ADDENDUM NUMBER 4
Prepared by
M. B. Kahn Construction Co., Inc.
Construction Management Division
Columbia, SC
LCM Design Group, Inc.
Lexington, SC
Date of issue: **May 11, 2011**

ADDENDUM NO.4

BLUFF ROAD PARK FACILITY
COLUMBIA, SOUTH CAROLINA

RICHLAND COUNTY RECREATION COMMISSION
COLUMBIA, SOUTH CAROLINA

PROJECT TITLE: RICHLAND COUNTY RECREATION COMMISSION BLUFF ROAD PARK FACILITY
 DRAWING TITLE: LANDSCAPE NOTES AND DETAILS
 PROJECT NO.: 12121
 DATE: JANUARY 28, 2011
 DRAWN BY: JLC
 CHECKED BY: PJC
 SCALE: AS SHOWN

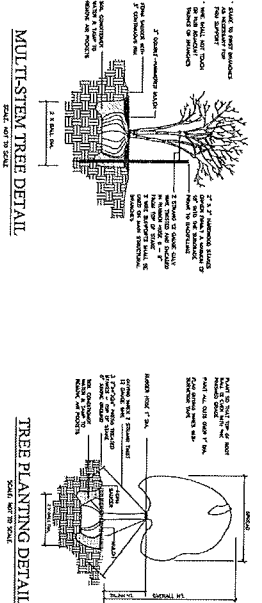
1. Revisions to Civil Drawings (Sheet L1 - Landscape Plan and L2 – Landscape Note)
 - A. Replace Landscape Plan – L1 with (Alternate Landscape Plan – L1).
 - B. Replace Landscape Plan – L2 with (Landscape Notes and Details – L2).
2. Revisions to Architectural Drawings (Sheet A306: Wall Sections)
 - A. Delete wall section 2/A306 in its entry.
